GROUP	MODEL
<b>Voluntary Service Campaign</b>	<b>2026MY Sportage (NQ5a) and Sportage P/HEV (NQ5 P/HEV)</b>
NUMBER	DATE
<b>SC350</b>	<b>October 2025</b>

### PDW OPERATION LOGIC IMPROVEMENT (SC350)

**This bulletin SC350, superseded the previously released TSB E4E400/SA629.**

**Upgrade Event #875**

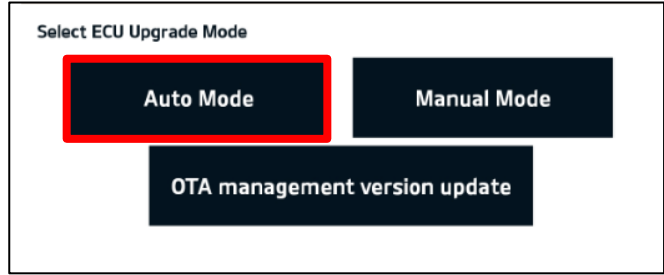
Model	System	IMMO 	ECU P/No.	ROM ID	
				Previous	New
NQ5a	BDC	YES	954AO DW000 954AO DW010 954BO DW000		
NQ5 (P/HEV)			954AO CH000 954AO CH010 954AO CH020 954AO CH030 954AO CH040 954AO CH500 954AO CH510 954AO CH520 954AO CH530 954BO CH000 954BO CH010 954BO CH040 954BO CH050 954BO CH070 954BO CH700 954BO CH710

To verify the vehicle is affected, be sure to check the Calibration Identification of the vehicle's ECM ROM ID and reference the Information Table, as necessary.
